OCAN081403

SUBJECT: Third Six-Month Status Report in Response to March 12, 2012,  
Commission Order Modifying Licenses with Regard to Reliable Spent  
Fuel Pool (SFP) Instrumentation (Order Number EA-12-051)  
Arkansas Nuclear One – Units 1 and 2  
Docket Nos. 50-313 and 50-368  
License Nos. DPR-51 and NPF-6

**Arkansas Nuclear One (ANO) Units 1 and 2 (ANO-1 and ANO-2) Third Six Month  
Status Report for the Implementation of Order EA-12-051, Order to Modify  
Licenses with Regard to Reliable Spent Fuel Pool (SFP) Instrumentation**

Attachment 2  
ANO Unit 2 – SFPI Simplified Spent Fuel Pool Instrument  
Approximate Locations and Approximate Cable Routing

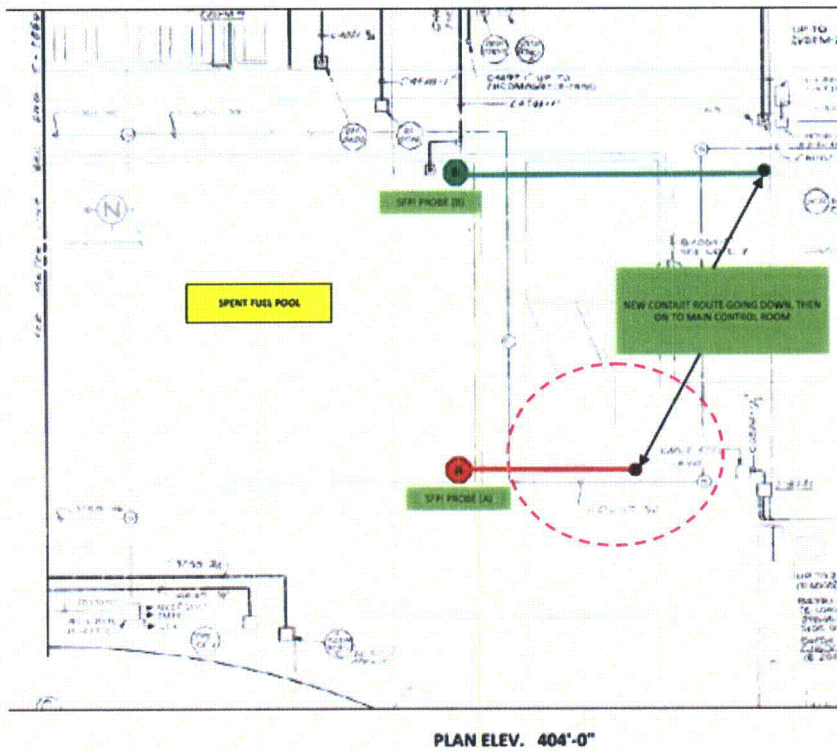
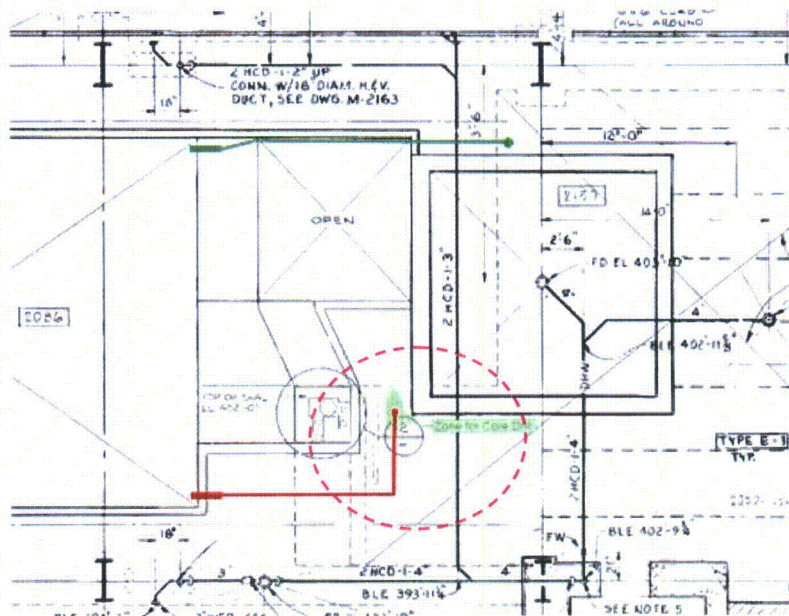
OIP (Reference 1) Attachment 2 (ANO Unit 2 – SFPI, Approximate Sensor Location and Approximate Cable Routing) is updated relative to Channel A cable routing. See Figure 1 and Figure 2. Original showed sensors located in opposite corners of the SFP's short side (which is not changed) with the cable routing from the sensors proceeding due south and maintaining the same relative sensor spatial separation out to the floor penetrations (which is changed). Channel A floor penetration location (and related cable routing) is revised due to interference on the elevation below. The change brings the Channel A cable routing closer to the opposite channel (i.e., spatial separation is less than the SFP's short side). However, substantial and adequate spatial separation is maintained ( $\approx 3/4$  of that original planned). Also, unchanged is the reasonable protection provided by seismically mounted protective metal raceway and additional protection afforded by objects in the vicinity which rise above the floor grade (e.g. SFP curbs and/or SFP bridge tracks/rails). Information associated with the NRC RAI #4.a (Reference 6) response and information preceding NRC ISE RAI #11 (Reference 3) discusses cable routing maintaining the same relative sensor spatial separation and, as such, is impacted and also updated.
